## **Addendum #2**

**Bid Opportunity: 7251-RW-22**

### **Waterloo Oxford District Secondary School - Family Studies Renovation & HVAC Upgrades**

A1.2R

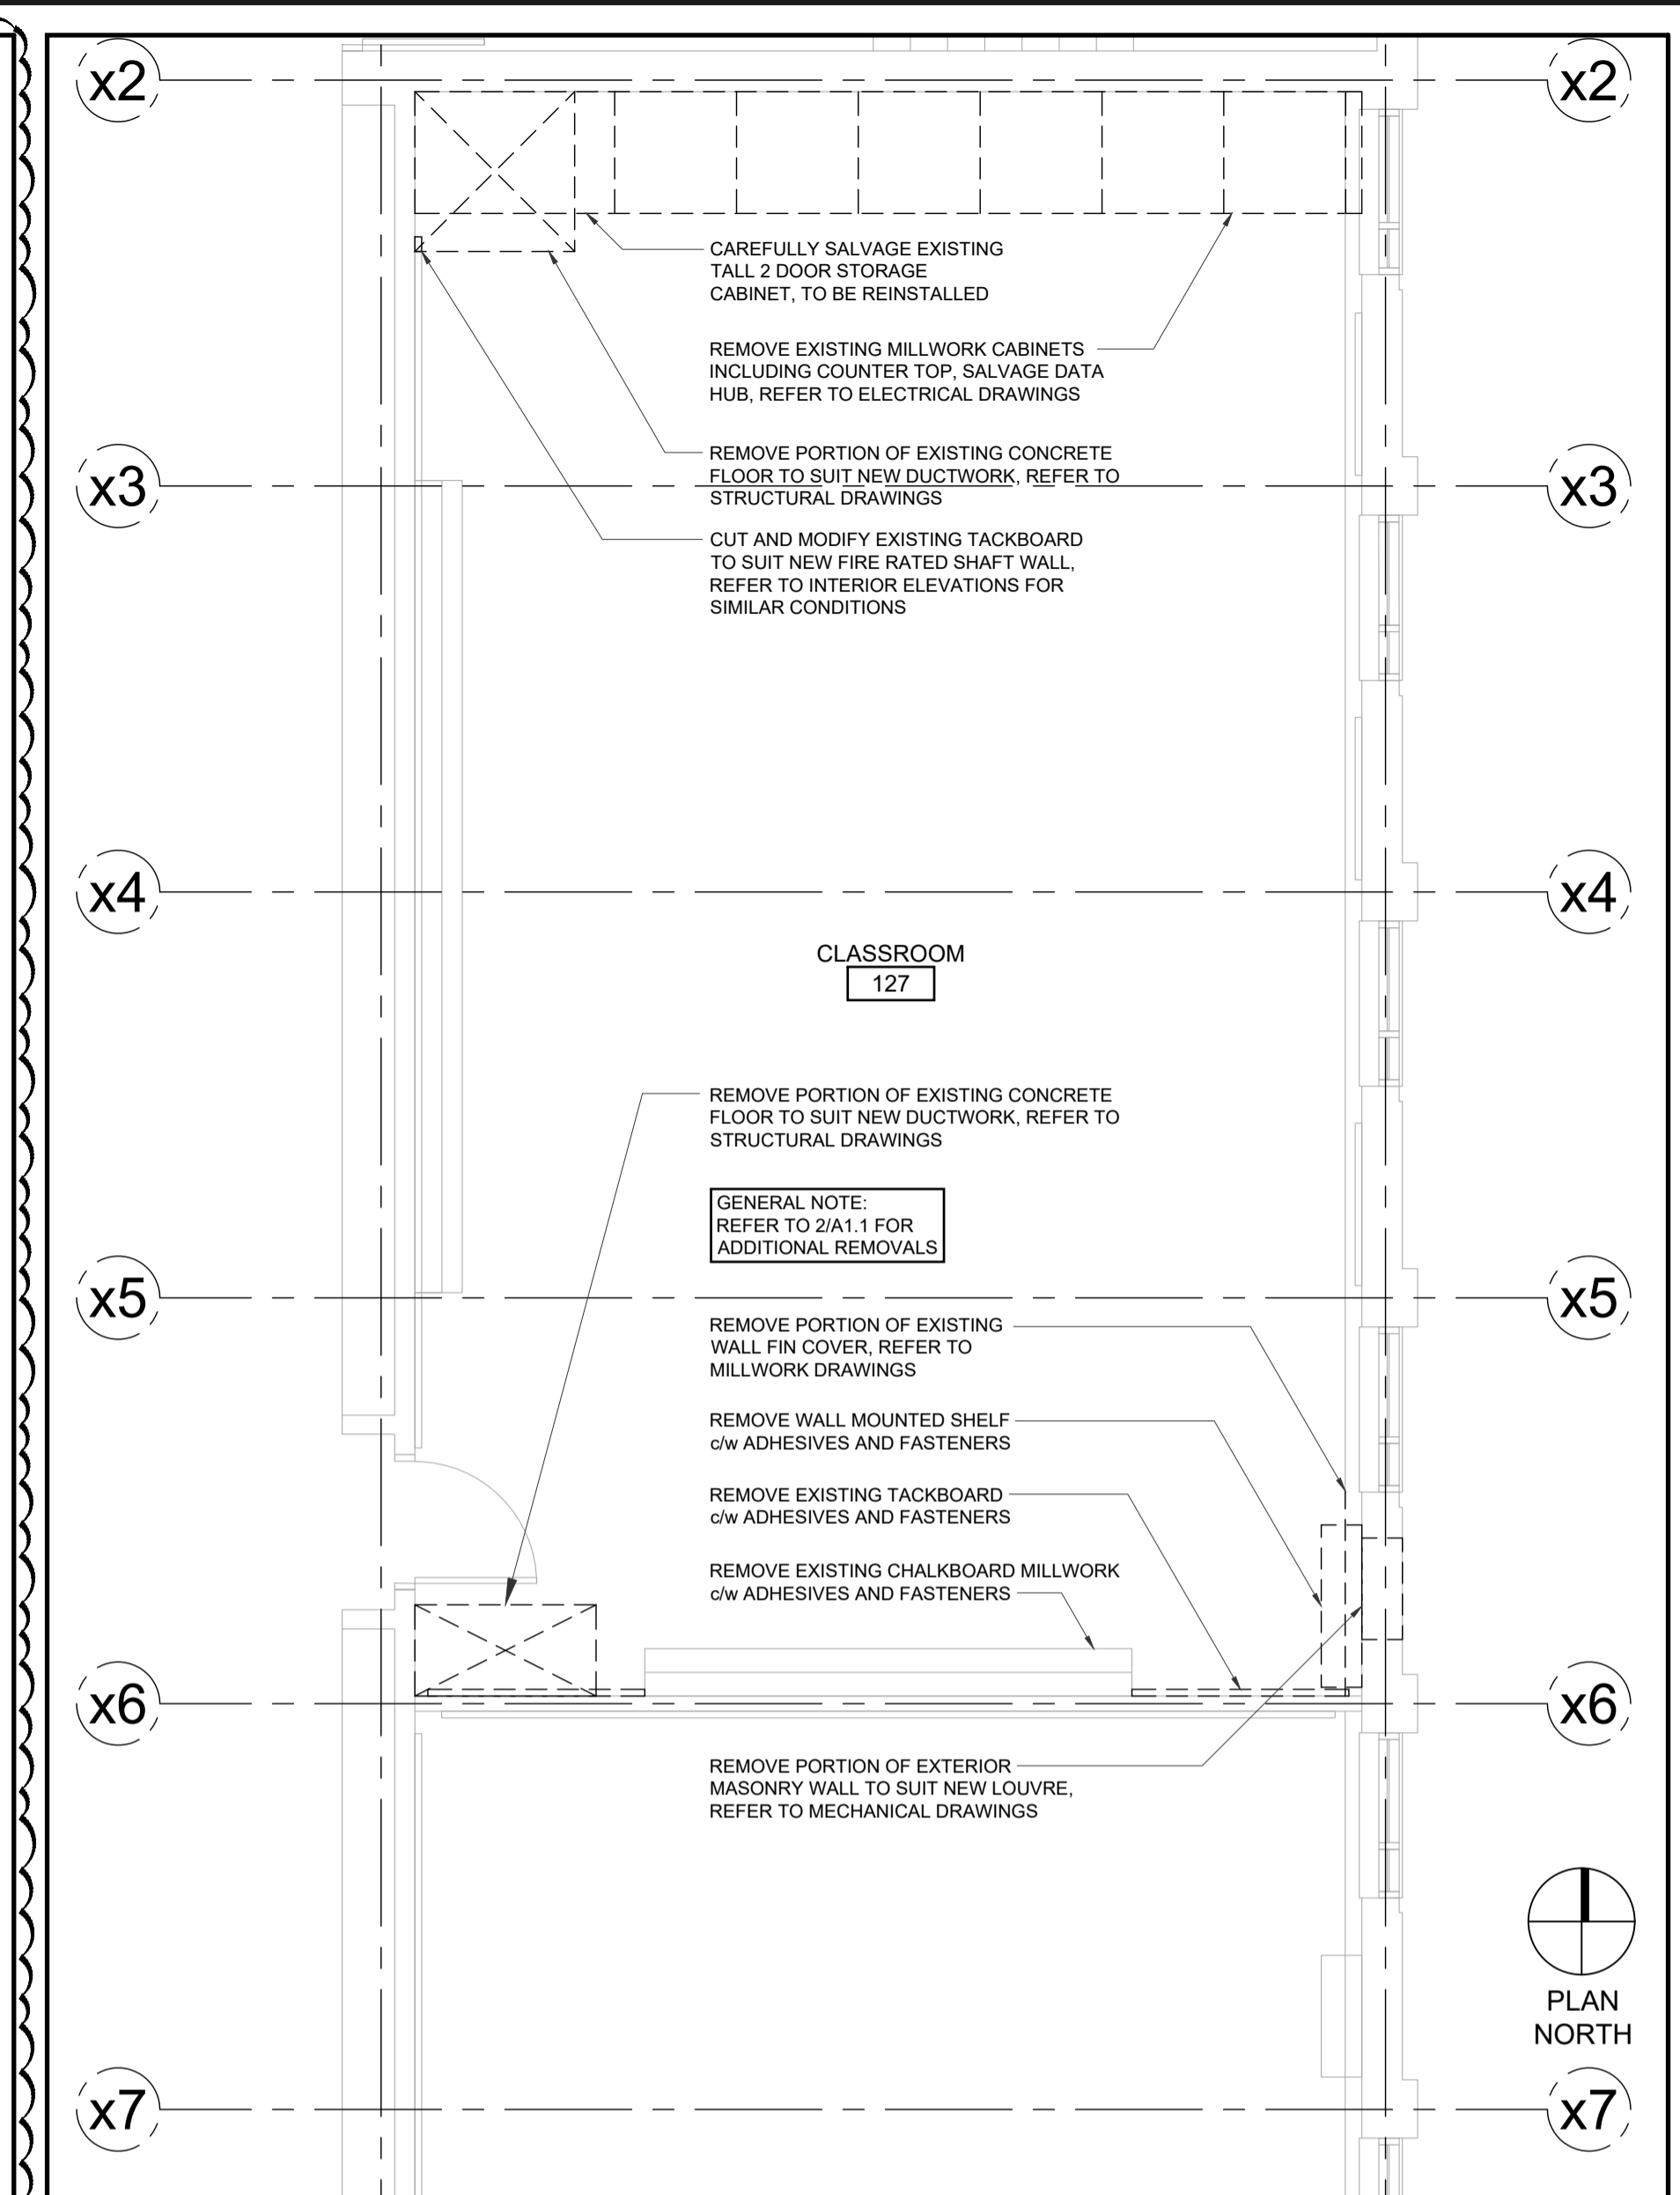
1. Drawing A0.0 OBC Matrix, General Notes, legends, Abbreviations, Drawing List
  1. **ADD DETAIL FOR GREASE INTERSEPTOR, AS SHOWN ON DRAWING ASK-001, ATTACHED.**
  2. **ADD FLOOR TYPE FOR INFILL OF SLAB-ON-GRADE, AS SHOWN ON DRAWING ASK-001, ATATCHED.**
2. Drawing A1.1 Partial Demolition Floor Plans
  1. **ENLARGED SECOND FLOOR DEMOLITION PLAN 2/A1.1 – PROVIDE OPENING FOR NEW LOUVRE AS SHOWN ON DRAWING ASK-002, ATTACHED.**
3. Drawing A1.2 Enlarged Demolition Plans & Partial Site Demolition Plan
  1. **REPLACE DRAWING A1.2 WITH DRAWING A1.2R, ATTACHED.**
    1. **1/A1.2 REVISED TO SHOW FLOOR CUTS REQUIRED FOR NEW SERVICES.**
    2. **1/A1.2 REVISED TO SHOW NEW OPENINGS FOR DUCTWORK.**

A2.2R

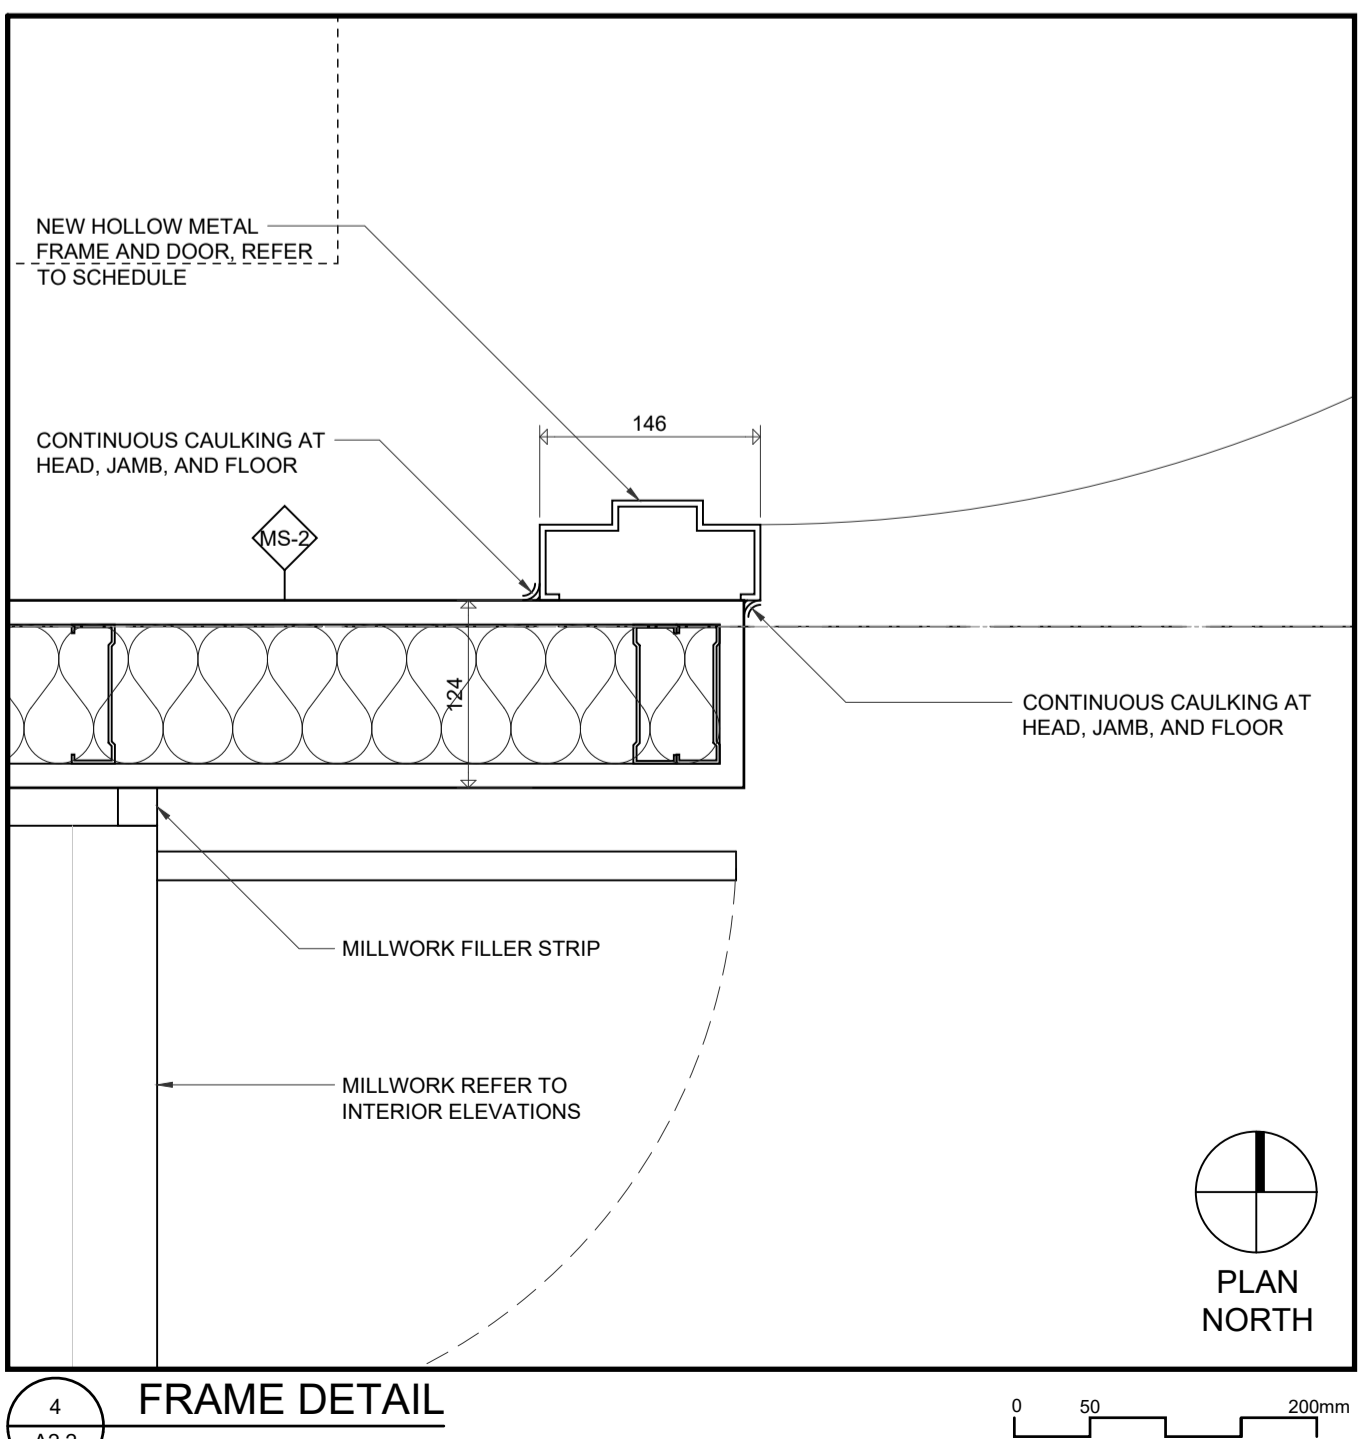
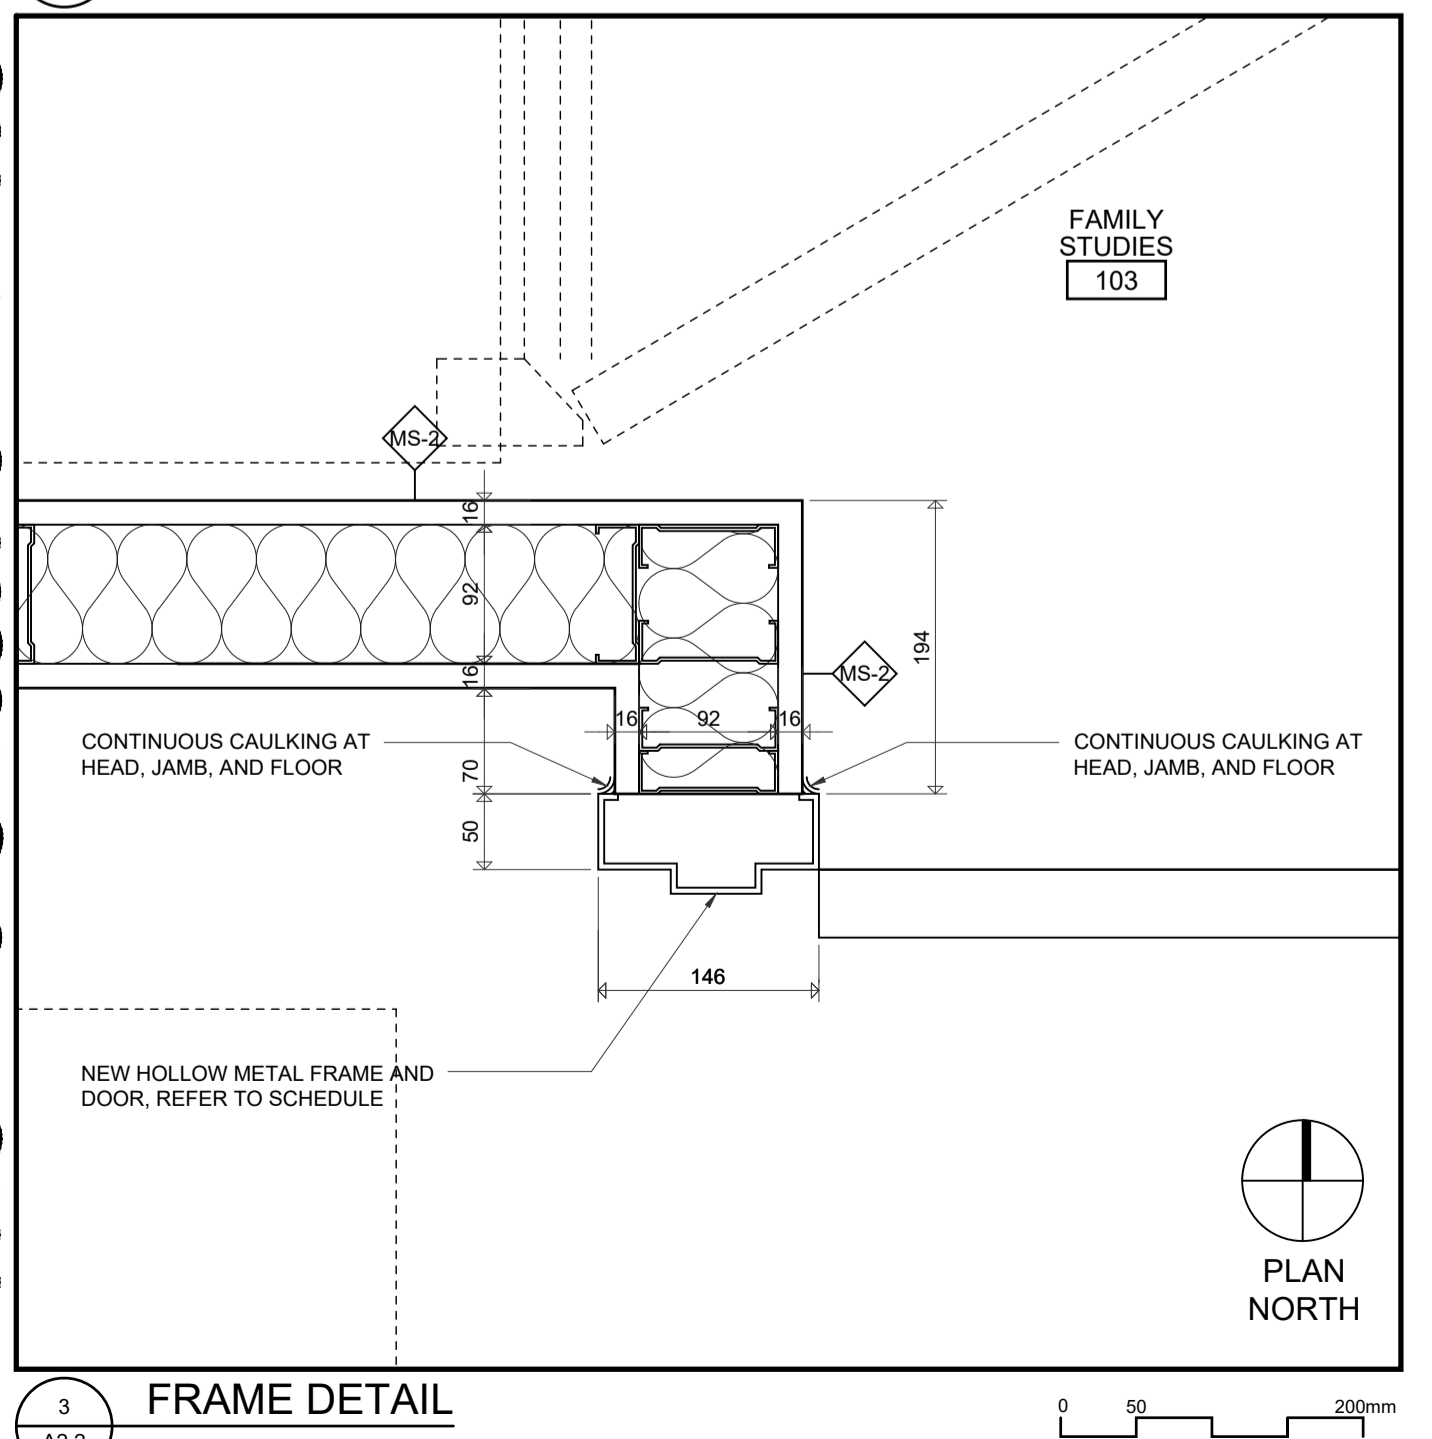
5. Drawing A2.2 Enlarged Floor Plans & Plan Details
  2. **REPLACE DRAWING A2.2 WITH DRAWING A2.2R, ATTACHED.**
    1. **1/A2.2 REVISED TO SHOW FLOOR INFILLS REQUIRED; NEW OPENINGS FOR DUCTWORK.**
